TO: Members of the MAG Standard Specifications and Details Committee

SUBJECT: MEETING NOTIFICATION AND TRANSMITTAL OF TENTATIVE AGENDA

MAG Standard Specifications and Details Committee
TENTATIVE AGENDA
August 1, 2012

MEETING MINUTES FROM THE
MARICOPA ASSOCIATION OF GOVERNMENTS
STANDARD SPECIFICATIONS AND DETAILS COMMITTEE

DETAIL NO.
201

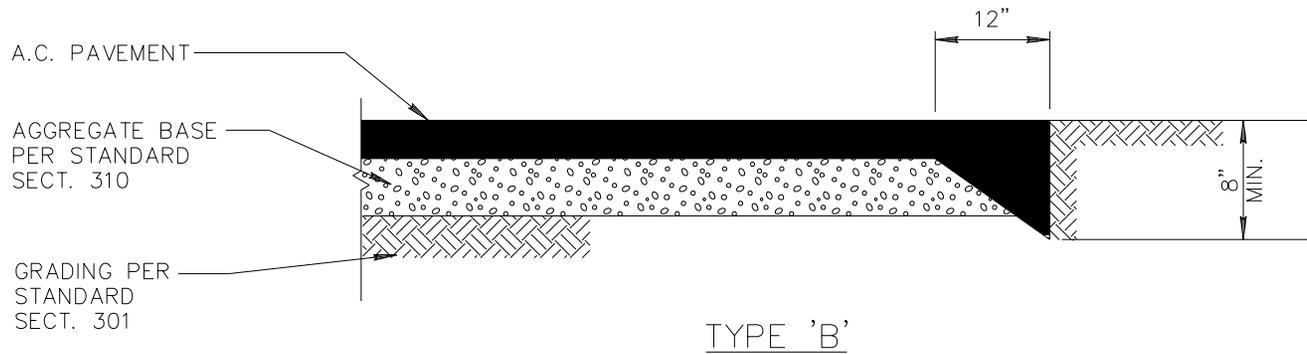
CASE 11-02

ASPHALT PAVEMENT EDGE DETAILS

360-1

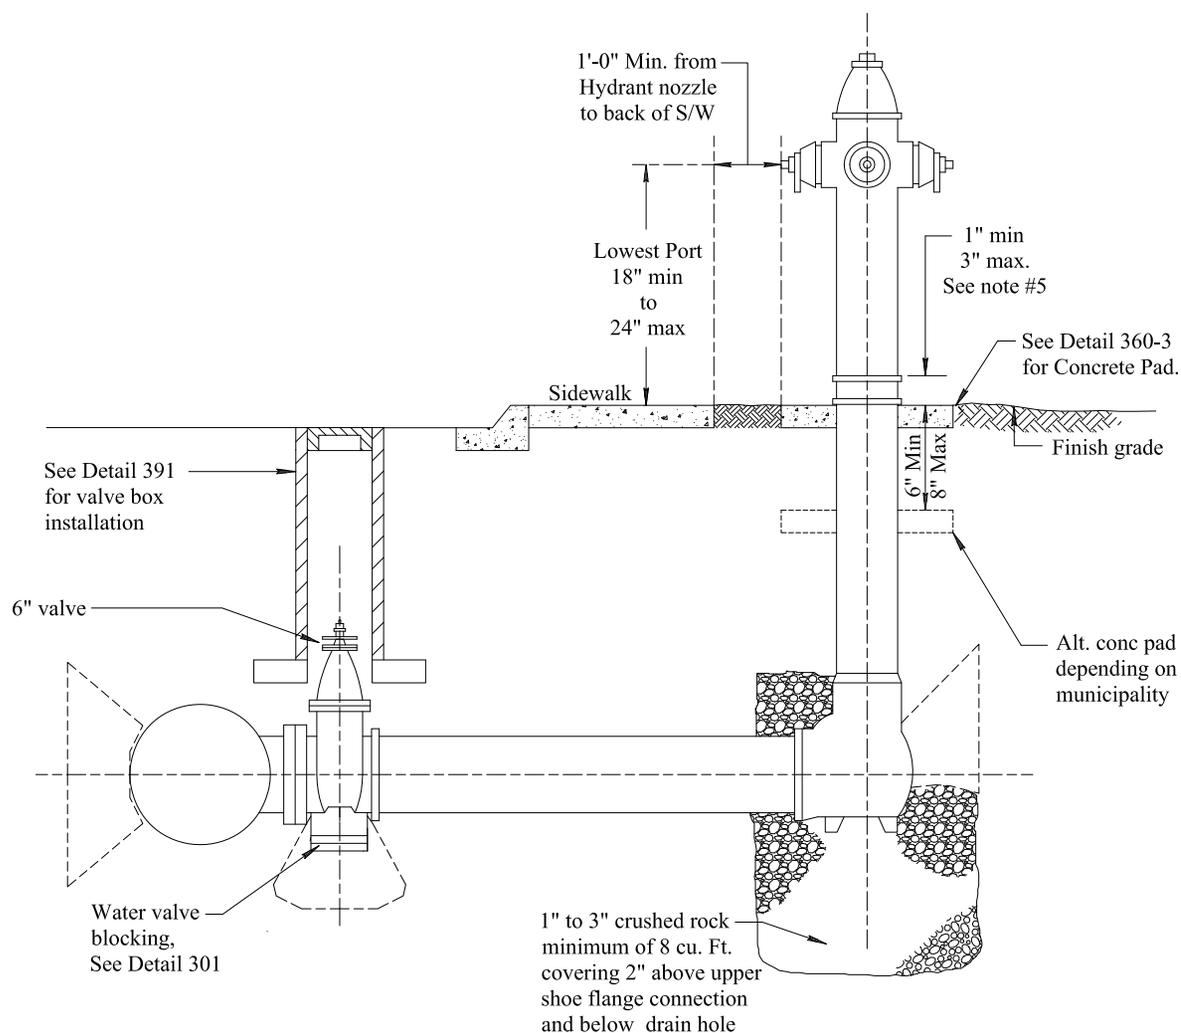
8. Case 11-14: Update Fire Hydrant Details

Update Detail 360-1, and add Wet Barrel Option (360-2) and Details (360-3). Craig Sharp said the revised details in the packet were based on revisions hashed out during the June water/sewer working group meeting. He asked members to do a final review, so they could be voted on at the August meeting. Jim Badowich highlighted some of the changes, including the minimum clearing of 36” based on the NFPA-24 code. Agencies that wanted a larger clearance would have to provide a supplement. Jason Mahkovtz suggested combining notes 5 and 6 on detail 360-3. Jami Erickson asked to have revision dates updated so she would know what the latest version was. Paul Nebeker questioned note 11 on detail 360-2 about two-port hydrants. Jim Badowich said that the wet-barrel hydrants for residential use that they have installed in Avondale do have only two ports. Craig Sharp asked for comments so he can provide final updated details with the intent to vote on the case at the next meeting.

DETAIL NO. 260	 MARICOPA ASSOCIATION OF GOVERNMENTS	STANDARD DETAIL ENGLISH	ALLEY ENTRANCE (WITH COMBINED CURB AND GUTTER)	REVISED 05/02/2012 DRAFT	DETAIL NO. 260
-------------------	---	----------------------------	---	--------------------------------	-------------------

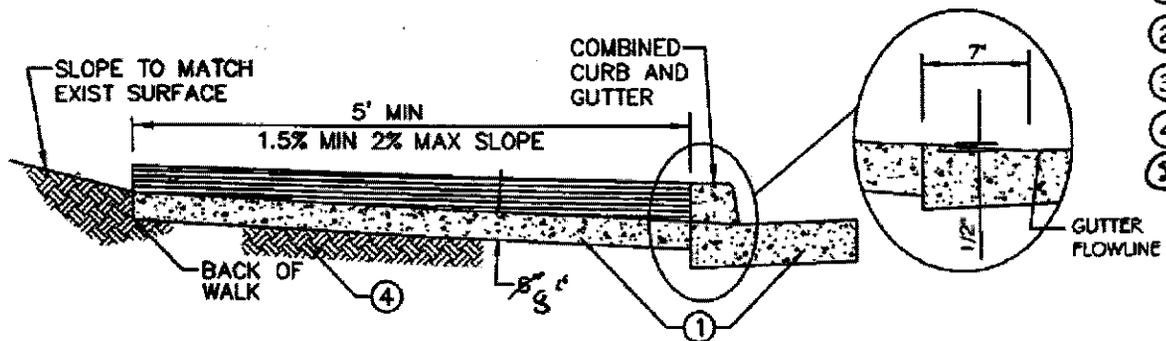
Create a new entrance detail meeting ADA requirements for straight sidewalks. Warren White provided an updated Alley Entrance Detail 260. It added a note 5: 6" SINGLE CURB PER MAG DETAIL 222, TYPE B. Syd Anderson suggested changing Note 1 to CLASS "A" CONCRETE to be consistent with other details. Warren White asked members if Note 5 should be optional. Tom Wilhite described a retrofitting application with curbing. Mr. White asked if the detail should be shown with or without curbing. Rod Ramos suggested a split plan view to show both. Mr. White said he would continue with revisions.
